MEMORANDUM

REVIEW TYPE: Preliminary Plan of Subdivision

PROJECT NAME: Pipkin Property

CASE NUMBER: 1- 02052

PRELIMINARY PLAN
P157
RIDGEFIELD CITIZENS, INC.
HARTFORD, CONNECTICUT

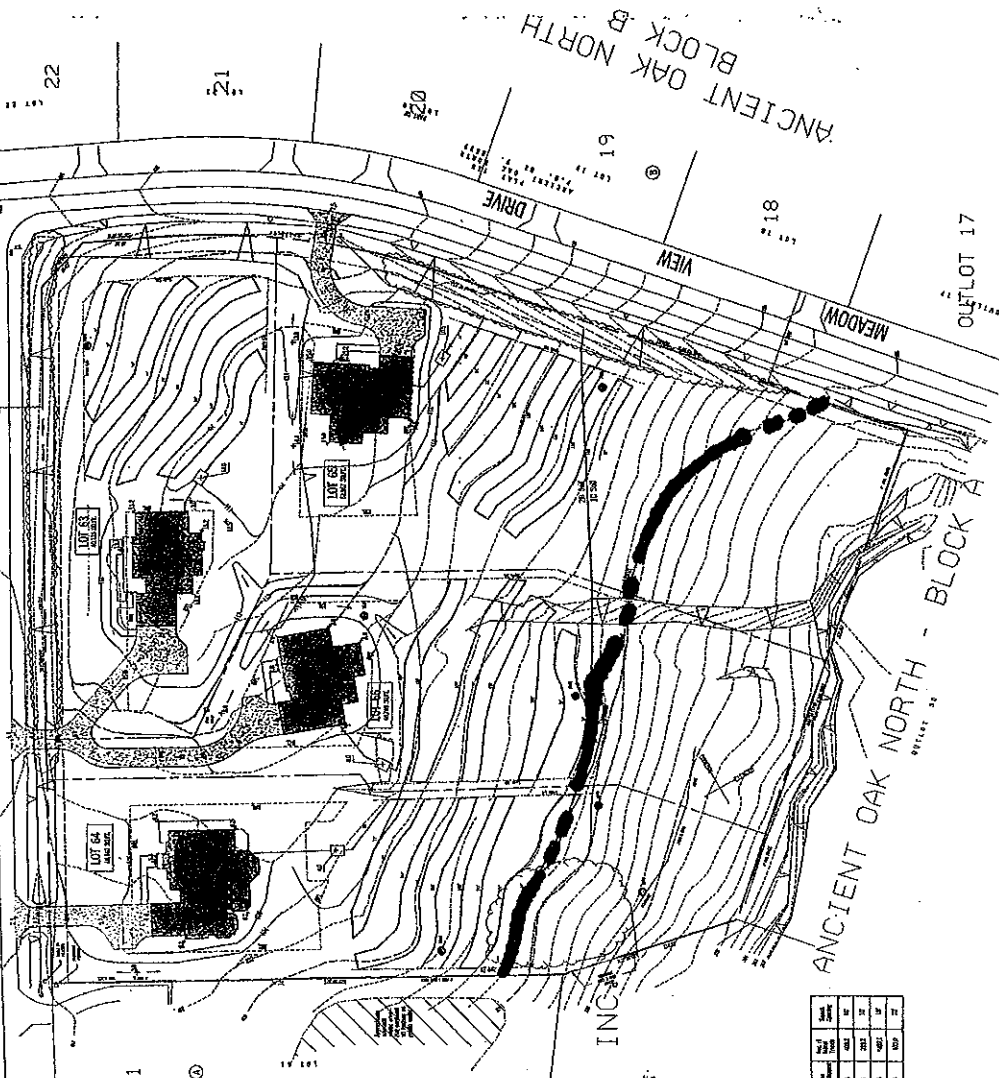
Although the proposed subdivision has met all the minimum requirements of the RE-1 zone, staff finds the orientation of Lot 66 to be incompatible and in addition, Lot 66 would be inconsistent with the orientation of the surrounding properties in the Ancient Oak North subdivision. Most of the existing homes have front yard setbacks within fifty feet of the front lot line, whereas Lot 66 has a front yard setback in excess of 140 feet. The property is configured with a pipe stem on Green Meadow Road for frontage with remaining body of the property behind Lot 63 and 65. Additionally, due to the configuration of Lot 66 the house orientation is placed somewhat behind the home on proposed Lot 63. The resulting configuration is not typically demonstrated in the surrounding community.

The bulk of the four (4) acre site is restricted due to the location of septic fields and a conservation easement over the area of stream buffer located on the southern end of the site.

Apparently Mr. Shaneman's main concern, according to his subdivision reviewers, is that the longer length of the driveway for Lot # 66 does not conform to the "character of the neighborhood" issue that I have discussed above. After reviewing the requirements of 59-C-1.32. *Development Standards*., it appears to me that the 50' requirement for setback from street is a minimum requirement. The site plan I have details the setback that is shown for Lot #66 as being over the minimum. Since the setback has to be at least 50', then that requirement has obviously been met. I don't see this having a negative impact on the neighborhood in any fashion. Visually, the lot does not pose much of an inconsistency because of the dense line of mature trees on the Green Meadow Road right-of-way directly to the right of the Lot #66 driveway, which screens much of Lot #66 and the house on it from the street.

- How much of the septic field for the existing house, occupied since 1964, is still viable? Is this field part of lot 63's septic area?
- Lot 66 is out of place. It is the fourth and the awkward house, plopped down into the backyards of the other three proposed houses. This house makes the plan incompatible, especially as part of a resubdivision in the existing neighborhood. We anticipate that this forced, fourth house would also be resented by the residents in the other three new houses.

- 1) The orientation of the houses in this plan is not consistent with the existing houses in this neighborhood.
- 2) The driveways proposed for these houses are not consistent with those in the neighborhood. Further, three driveways near to each other and directly across from two existing driveways looks awkward and could become a problem.
- 3) The house proposed for Lot 64 is so big and fancy as to be out of character for this neighborhood.

The planners should make the fronts of the houses face and be parallel to the streets. The corner house on Lot 63 could face the corner, if that is desired. No one wants to see the back of a house at such a prominent place in the neighborhood, and those properties across the streets from the corner would surely suffer loss of desirability and value by facing the back of that house.

The lot boundaries should be redrawn so as to provide Lot 66 more front footage on Green Meadow Dr. Eliminating the winding driveway on Lot 63 and replacing it with a straight driveway onto Meadow View Dr. should make this possible.

- (1) Submit revised preliminary plan for staff review and approval depicting three (3) lots. Plan to include house locations, sewage disposal fields and site grading

- (1) Submit revised preliminary plan for staff review and approval depicting three (3) lots.
Plan to include house locations, sewage disposal fields and site grading
